**SUNDRY NOTICES AND REPORTS ON WELLS**  
(Do not use this form for proposals to drill or to deepen or plug back to a different reservoir.  
Use "APPLICATION FOR PERMIT—" for such proposals.)

2. NAME OF OPERATOR  
Union Oil Company of California

7. UNIT AGREEMENT NAME  
Rincon Unit

Attachment to Notice of  
Intention to Abandon

RINCON UNIT Well No. 8

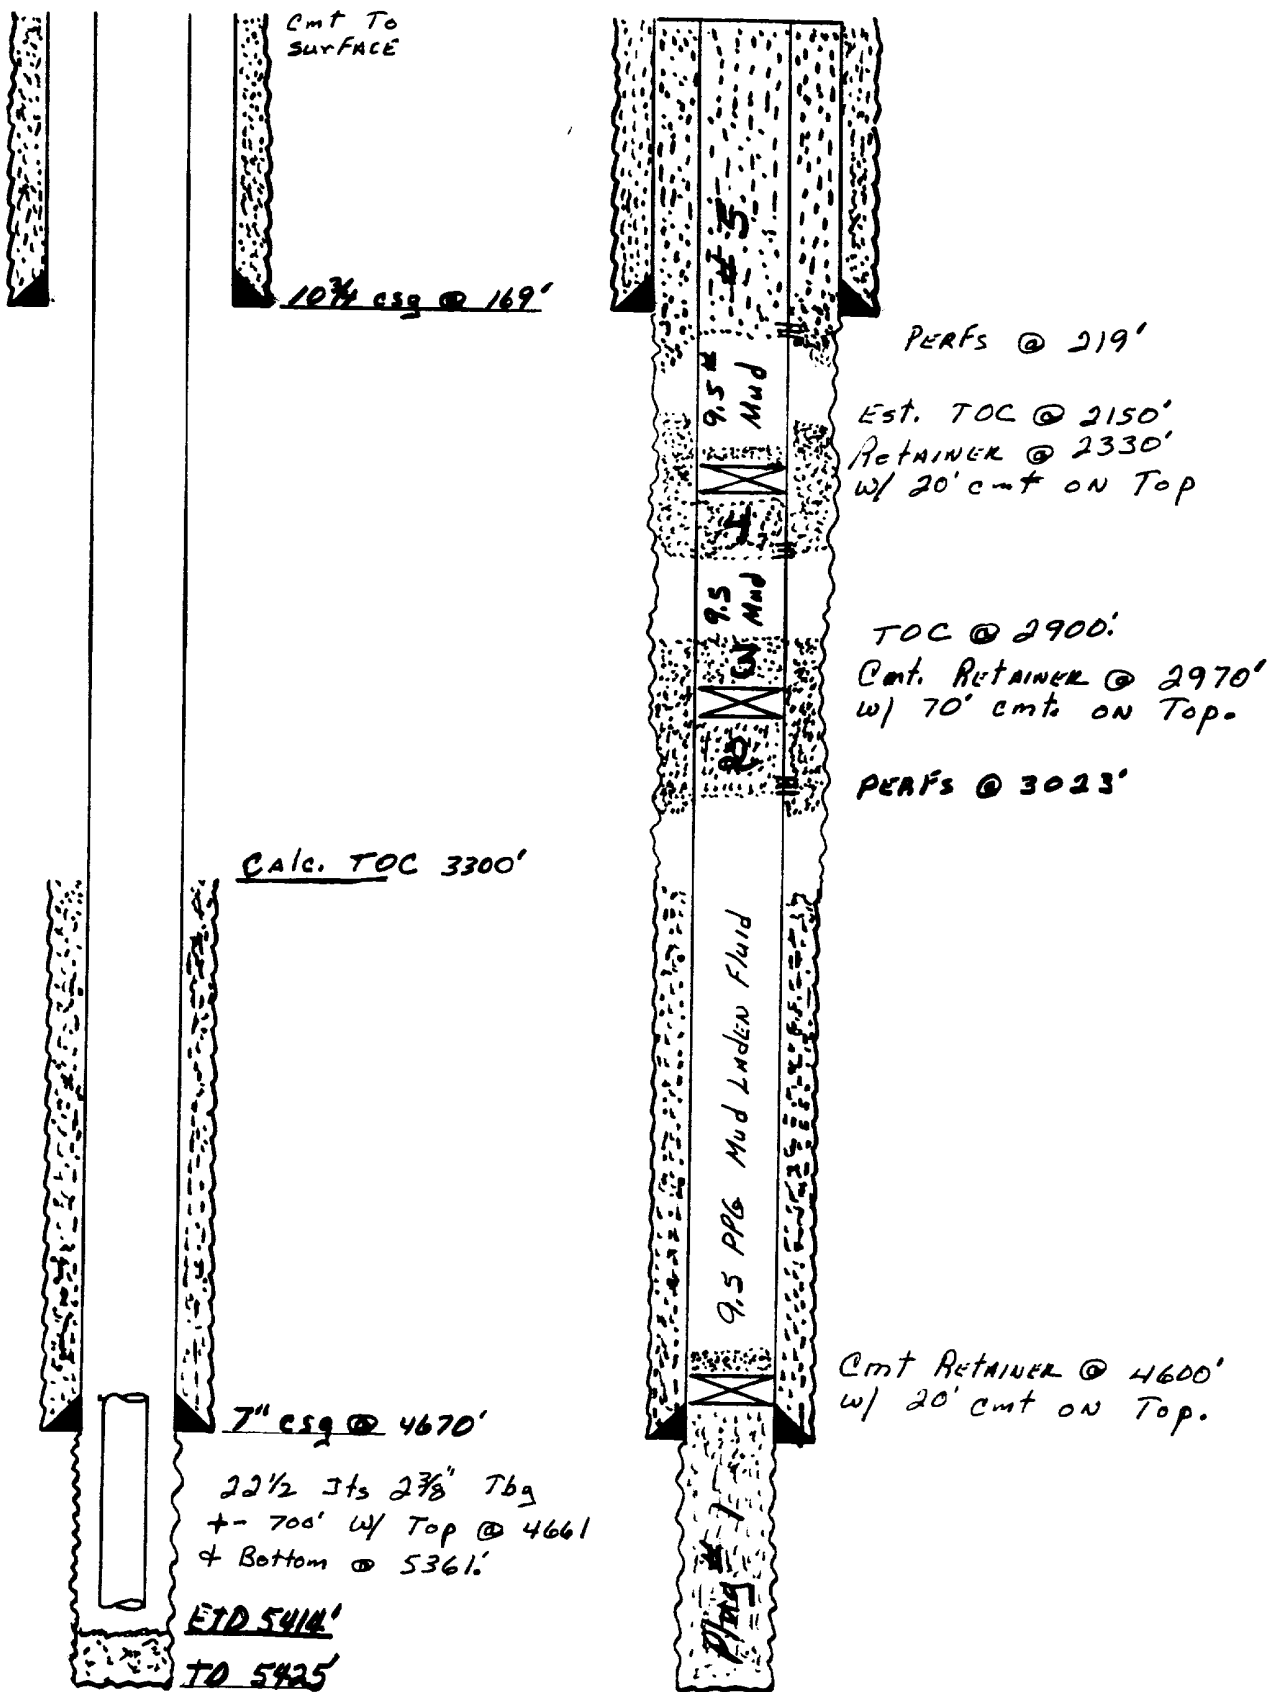
4. The following modifications to your plugging program are to be made (when applicable):

Add a plug from 4033 - 3883 30SX

Perf @ 3073' plug inside & outside 7" casing from 3073' - 2900'

" " 2827 " " " " " 2827' - 2727'

" " 2520 " " " " " 2520' - 2220'

Add a plug from 1182 - 1082 inside & outside 7" casing.
